Release Note

Edgecore ECW5210-L Release v3.45.0000

Document # Edgecore_ECW5210-L_v3.45.0000_1.5-1.9725

Enhancement from v3.43.00_1.3-1.9314

1.1 LLDP

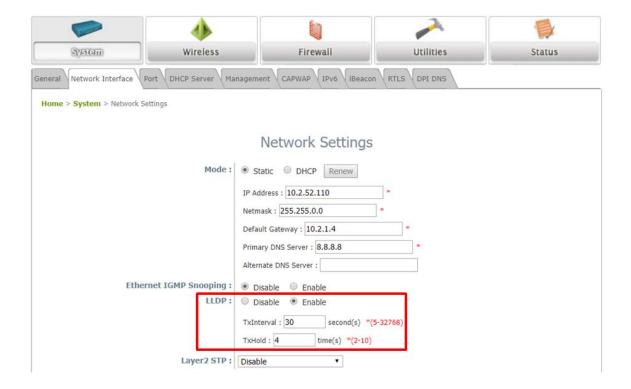
Add LLDP in Network Interface page of System.

TxInterval: Setting the interval for sending the packets.

TxHold: Setting the times of interval for sending the packets.
